**Re: Response to Comments and Revised Work Plan for Training Facility  
Soil Excavation Project  
Freeport Sierrita Mine  
Green Valley, Arizona; Site Code: 100073-03**

**Former CLEAR Plant Area  
Soil Excavation Work Plan**

Sierrita Mine  
Green Valley, Arizona

**TRAINING FACILITY  
 SOIL EXCAVATION  
 WORK PLAN**

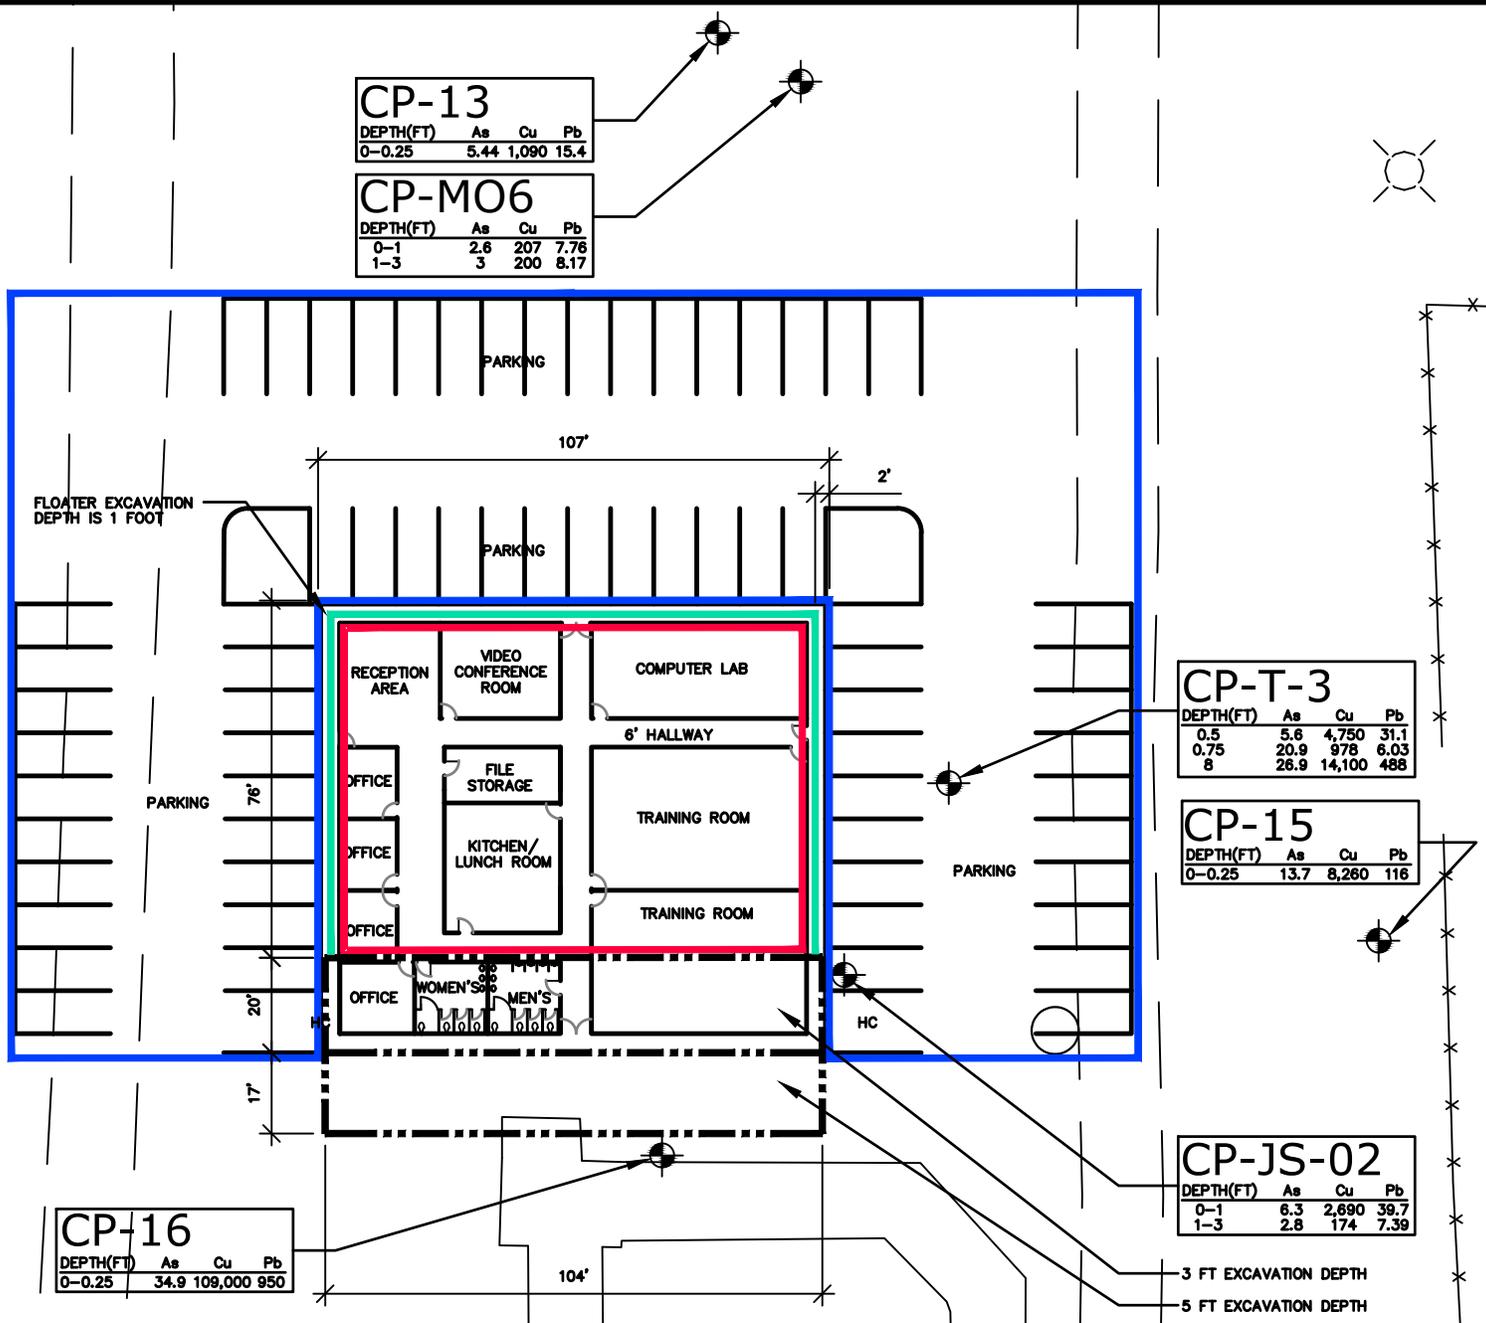
- b. *For convenience and clarification, please modify Figure 3 to include the analytical results for the labeled samples, and the dimensions in length, width, and depth for each footer excavation and the southern excavation area. Please add sample ID CP-13 in its proper orientation relative to the proposed Training Facility.*

2R. Figure 3 has been modified as requested by ADEQ.
